To: Salt Lake City Planning Commission  
From: Daniel Echeverria, (801) 535-7165, [Daniel.echeverria@slcgov.com](mailto:Daniel.echeverria@slcgov.com)  
Date: June 4<sup>th</sup>, 2015  
Re: Bishop Place Planned Development Approval Time Extension Request

RE: Record of Decision for Petition PLNSUB2014-00020/21: Bishop Place Planned Development and Preliminary Subdivision

To: Salt Lake City Planning Commission  
From: Daniel Echeverria, 801-535-7165, Daniel.echeverria@slcgov.com  
Date: June 18, 2014  
Re: PLNPCM2014-00021 432 N 300 West Zoning Amendment; PLNSUB2014-00019/00020 Bishop Place Planned Development and Subdivision

**BISHOP'S PLACE**

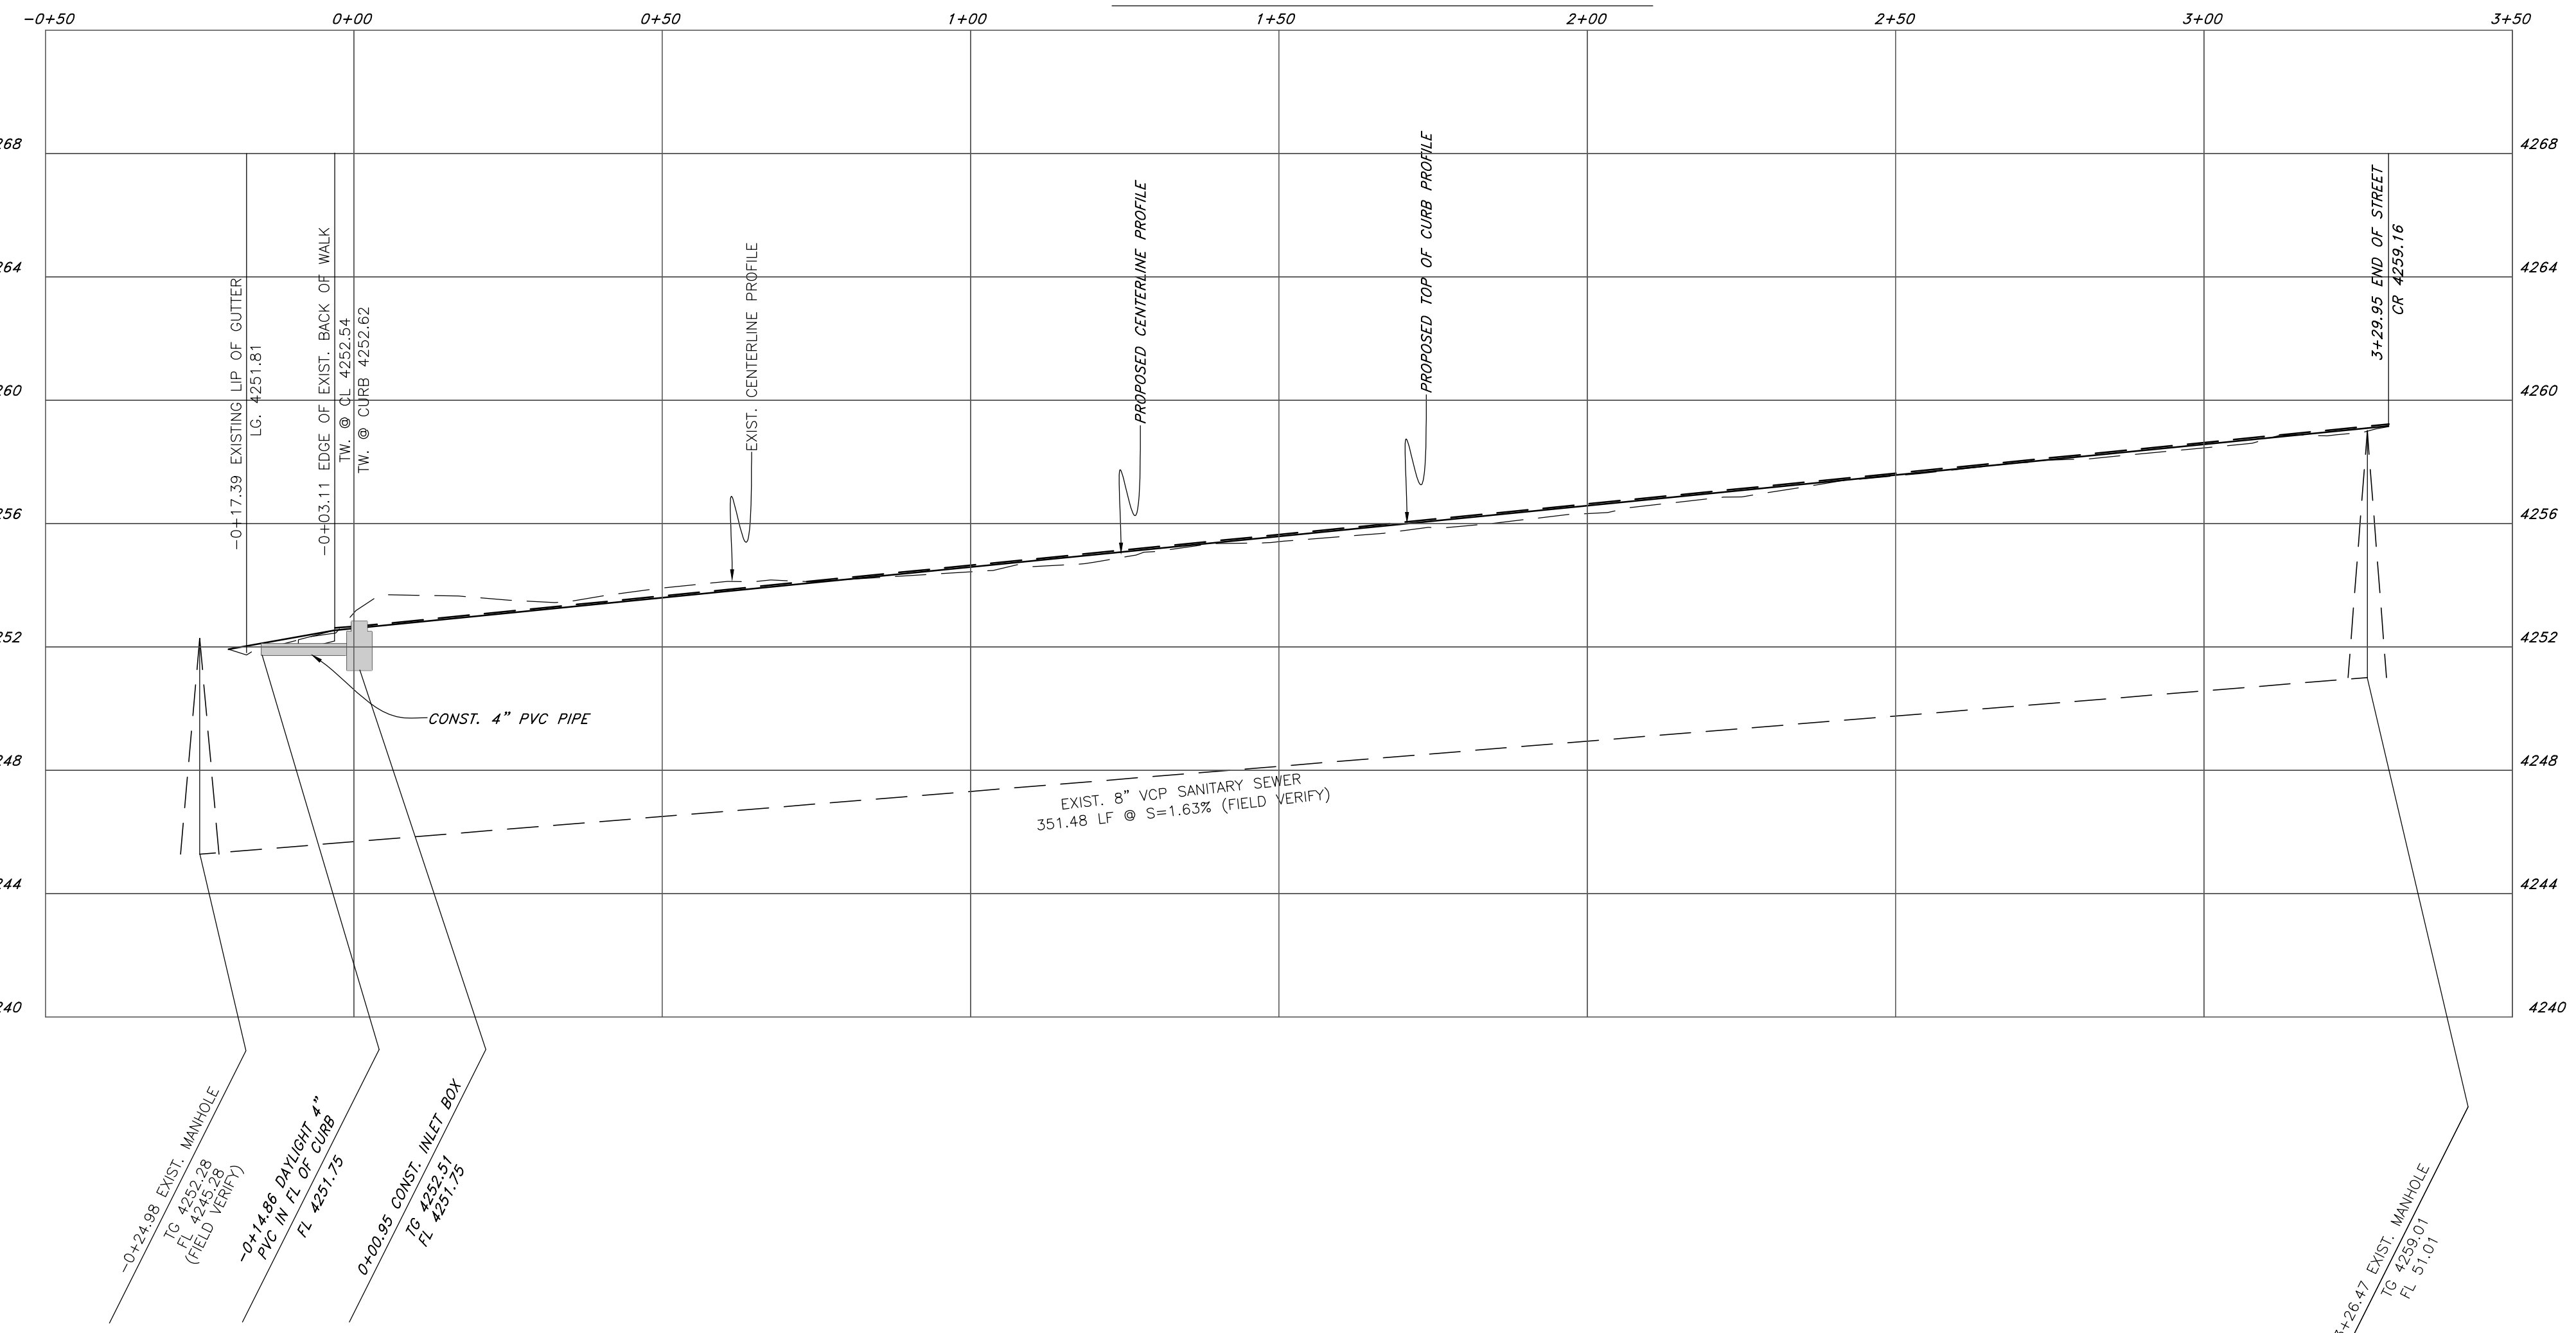
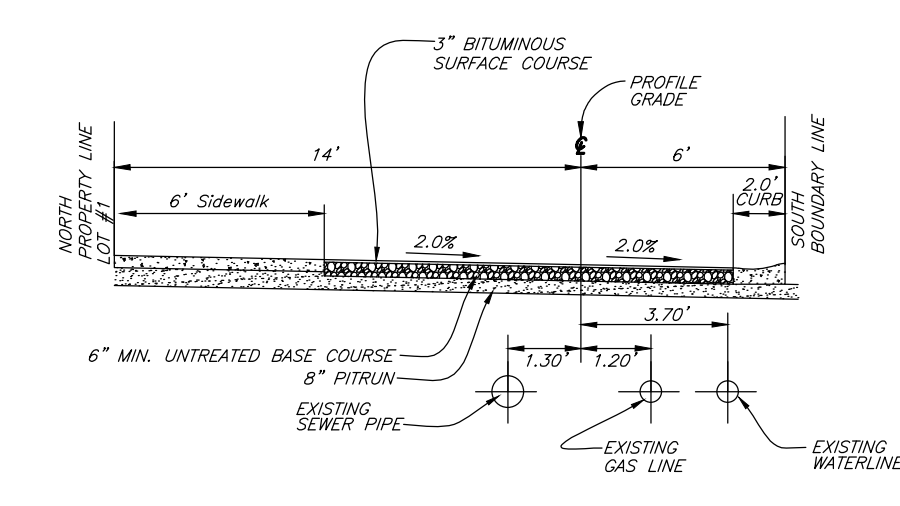
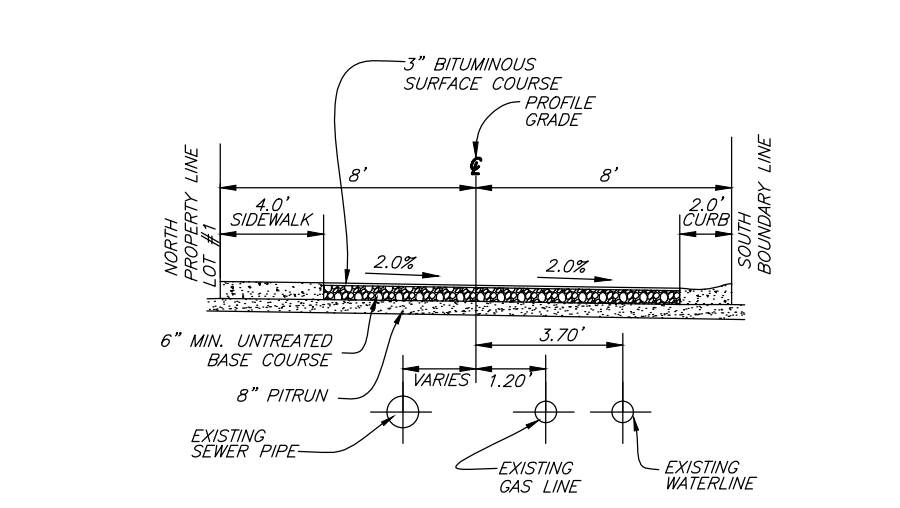
Normally, the street would need to be at least 20' in width and have a fire vehicle turnaround to meet Fire Code standards. However, 20' of width is not available for the entirety of the street and so the normal Fire standard cannot be met. Due to this limitation, the applicant is proposing to provide fire protection with fire sprinkler systems for all homes to the east of the 18' wide portion of the street. The Fire department accepted the proposal and is modifying the requirement for a full size emergency vehicle turnaround and 20' of street width on the condition that fire sprinklers are installed in these homes and that the sprinklers are inspected annually.

The proposed street was reviewed by the Streets department, which is responsible for snow removal. The Streets department indicated that although a "T" type turnaround at the end of the street would be preferred, their smallest snow removal vehicles can turnaround within a 20' street width. They note that if there is just one car parked on the street, snow removal would not be possible. In response to the turnaround recommendation, the developer is proposing a semi-circular turnaround at the end of the street with a width of 37' at the widest point to accommodate the turnaround of snow removal and other larger vehicles. This reduces the potential for property damage from vehicles to the homes that directly abut the street.

The Engineering department reviewed the proposal and noted that the street configuration is dependent on Transportation and Fire Department approvals. A more detailed final street improvement plan will need to be developed and submitted to the Engineering division after the right-of-way configuration is approved.

The issues with turning around would be better resolved if the street had a "T" at the end. There are a couple of streets like this in the city and it works. The only other issue I can think of from my perspective is who is going to remove the snow that piles up at the end of the street? We typically do not have a free truck in the winter to haul snow away. If we unload a trucks to haul salt or snow, we could possibly do it then. 20' would be adequate to turn a F-550 around too.

It is extremely narrow where you enter off of 300 West. The turn is extremely tight and is on a (busy at times) roadway. There is an existing business on the south side where Bishop Place starts that is right up against the road. There is no buffer to avoid hitting the building, and this seems to be the most narrow part of the street. There may be room to widen this portion if the large trees on the north side are removed. There is really nowhere to push the snow on either side, not even a sidewalk right now, however I would think some sort of walkway is planned. There needs to be an area at the East end to turn around. At this time it is a very blunt "Dead End" street. In order to plow it, we would have to back down or back out. Both of these options would have us backing and stopping on 300 West which can be very dangerous. As it sits now, the service level will be provided by a F-550, and I see no way that another form of snow removal would ever be possible. My final observance is that if parking is allowed on this street during storms, plowing may be rendered impossible.

The police department has had significant problems regarding parking/property issues in neighborhoods with narrow "streets" such as this. Additionally, emergency response by the Fire Department can sometimes be delayed or blocked. An example of this type of area would be Laxon Ct. If the developer can include sufficient parking so that the street remains open for travel that would mitigate our concerns.

***Planning Staff Note:*** *In reponse to these comments, the applicant is installing a 37' wide turnaround on the street to accommodate snow removal vehicle turnaround.*

*Planning Staff Note: The applicant submitted an Alternative Means and Methods application to the Fire Department. The applicant requested approval of the proposed street on the condition that fire sprinklers are installed in all of the buildings on Bishop Place.*

1. The fire sprinkler systems is NFPA 13D with modifications
2. The fire sprinkler system it to receive annual inspections and maintained operational.
3. The sprinkler system shall be provided with tamper switches, and flow switch that is interconnected to an approved remote monitoring company.
